RTCA Special Committee 209
ATCRBS / Mode S Transponder MOPS Maintenance
Meeting #11

**Clarification for Regular Use of Non-Selective Lockout to Block
Mistaken Replies to ATCRBS Only All-Call**

Charles W. Sloane
Federal Aviation Administration, Avionics Systems Branch

This Working Paper is in response to Action Item 10-08.

Figure 2-13: All Transponders: Lockout Initiation Changes Highlighted

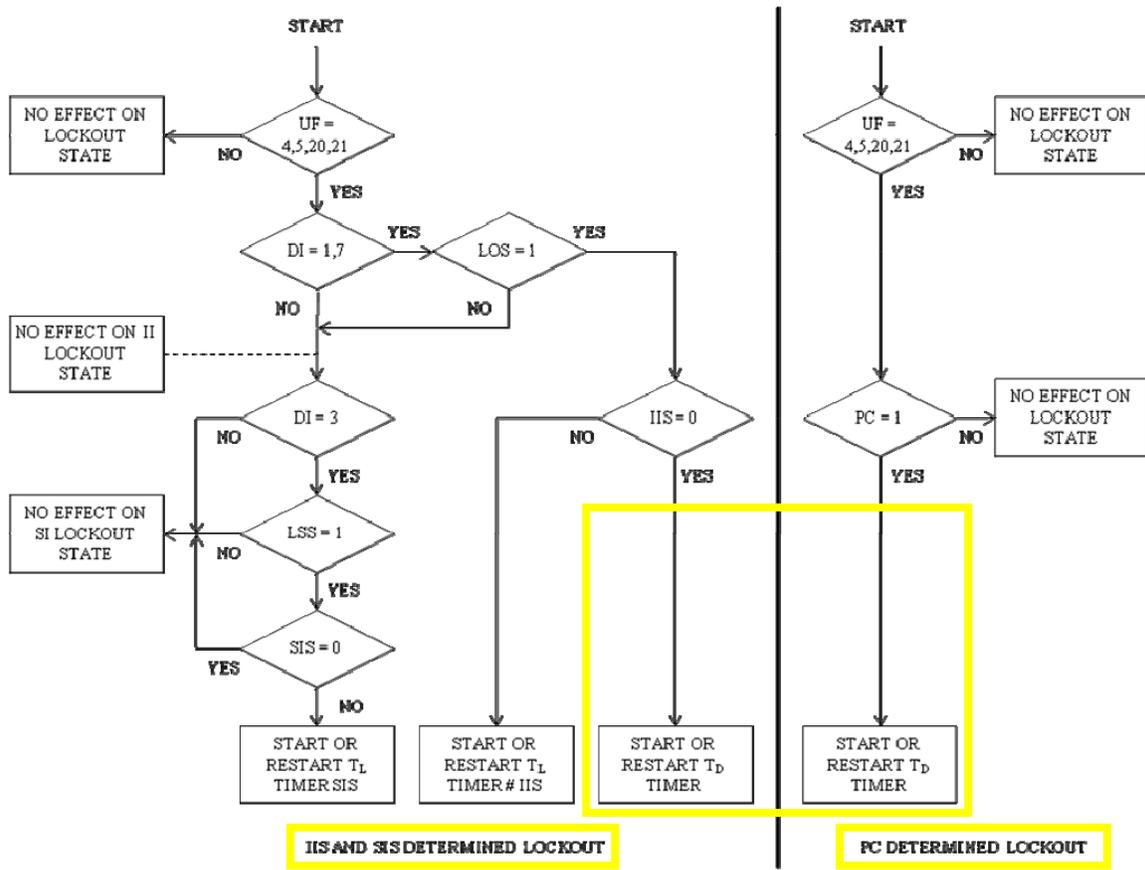
In DO-181D Figure 2-13 please make these highlighted changes (note the figure was reformatted out of convenience in editing for this paper):

FIGURE 3-11: LOCKOUT PROTOCOL **Changes Highlighted**

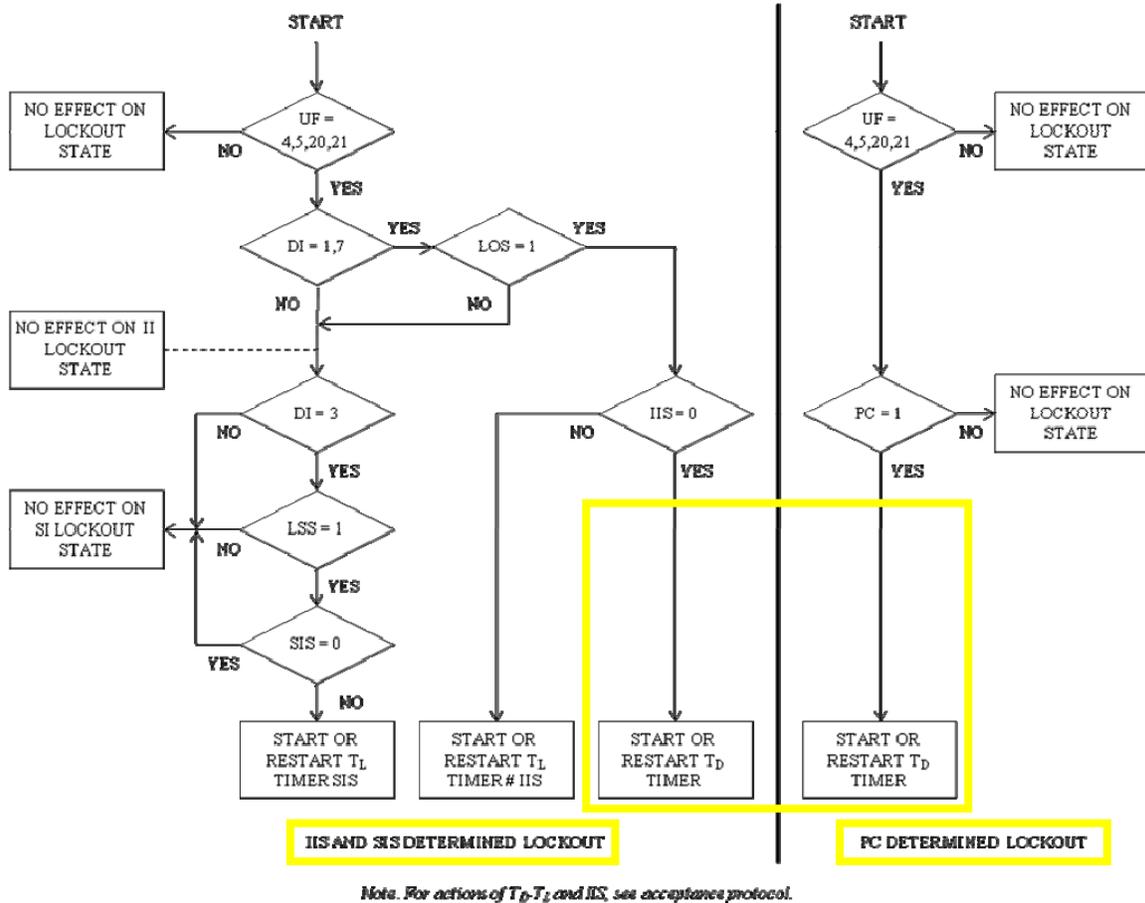
In ED-73C Figure 3-11 please make these highlighted changes (note the figure was reformatted out of convenience in editing for this paper):
